# Access Compliance Report

### (Curb Ramps)

Intersection ID: N/A	Main Street: MILLENNIUM_AV	Cross Street: ANSLEY_GARDEN_DR	Location: SW
ADA ID: 8AD9AEBE0889	Ramp Type: Directional1	Initial Pass/Fail: Fail	Overall Compliance: No
Severity Score: 12.5			
Codes/Mitigation Info/Possible Solution		Field Measurements/Component Compliance

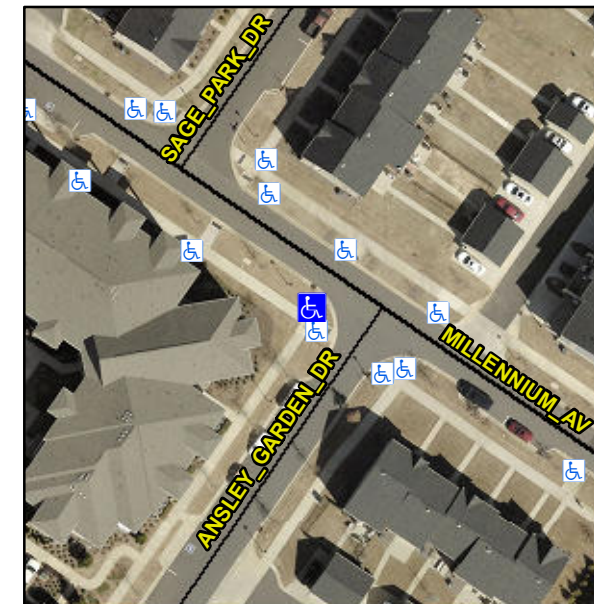
**R304.2.2**

Compliance	Description	Data	Compliance	Description	Data
N/A	Ramp Length (in)	100.0	N/A	Grade Break?	N/A
Yes	Ramp Width (in)	72.0	N/A	Grade Break Slope (%)	0.0
No	Ramp Slope (%)	8.6	N/A	Grade Break XSlope (%)	0.0
Yes	Ramp XSlope (%)	0.1			
N/A	Flare Type LT	N/A	N/A	Flare Type RT	N/A
N/A	Flare Slope LT (%)	N/A	N/A	Flare Slope RT (%)	0.0
N/A	Flare Traversable LT?	N/A	N/A	Flare Traversable RT?	N/A
N/A	Landing Length (in)	0.0	N/A	DWS Provided?	N/A
N/A	Landing Width (in)	0.0	N/A	DWS Contrast?	N/A
N/A	Landing Slope (%)	0.0	N/A	DWS Length (in)	N/A
N/A	Landing X Slope (%)	0.0	N/A	DWS Full Width?	N/A
N/A	Landing Curb? (Y/N)	N/A	N/A	DWS Offset LT (in)	N/A
N/A	Shared Landing?	N/A	N/A	DWS Offset RT (in)	N/A
N/A	Gutter Ponding?	0.0	N/A	Gutter Slope (%)	N/A
N/A	Gutter Lip Ht (in)	0.0	N/A	Gutter X Slope (%)	N/A
N/A	Painted X Walk1?	No		Road Slope (%)	3.4
	X Walk 1 Direction	To NE		Road X Slope (%)	2.6
	X Walk 1 Width (in)	N/A		Clear Space?	N/A

**Remove & Replace Entire Ramp.**
